Sunburst Shogrin Fed 1 SEC 22, 19S-34E, 1860 FSL & 1980 FEL Lea, NM API #3002529543

Plugging Procedure

NM-57285: Sunburst Shogrin Federal #1

RE: Plugging and Abandonment Requirements, Conditions of Approval

Proposal - Workover

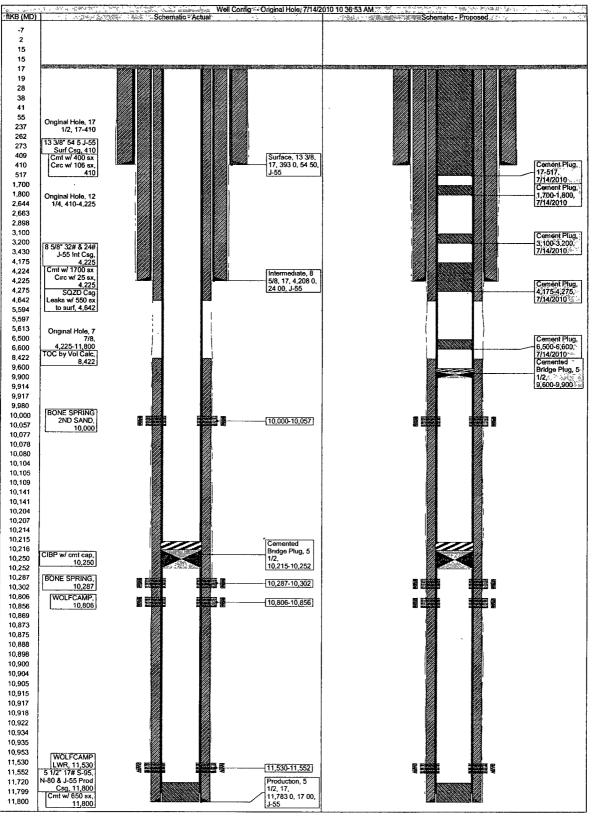
- 1. OK
- 2. OK
- 2a. Drill out CIBP at 10215'. Set CIBP at 11480' with 35' bailed cement or 25sx pumped cement. (Perfs)
- 2b. Spot a cement plug from 10960'-10750' (minimum 25sx). WOC and tag. If tag is deeper than 10750', attempt again. If tag is low, verify that cement is above 10860'. (Wolfcamp Perf attempt)

- 2c. Set CIBP at 10215' and bail 35' or spot 25sx on top. (Perfs)
- 3. OK
- 4. OK (Perfs)
- 5. Change: Perf and squeeze a plug from 8230'-8050'. WOC and tag at 8050' or shallower. If injection rate cannot be established, spot cement 50' below perfs. (Bone Spring)

- 5a. Perf and squeeze a plug from 5650'-5490'. WOC and tag at 5490' or shallower. If injection rate cannot be established, spot cement 50' below perfs. (Delaware)

- 6. Tag at 4135' or shallower Otherwise OK (Casing shoe)
- 7. Move: Spot plug from 3550'-3410' Otherwise OK (Yates BOS)
- 8. Move: Spot a plug from 1970-1850'. WOC and tag at 1850' or shallower. (TOS)

- 9. OK (Casing shoe Surface)
- 10. Verify cement to surface in all annuluses Otherwise OK
- 11. Ground Level Dry Hole Marker required in this area. **Requirements Attached.** Otherwise OK
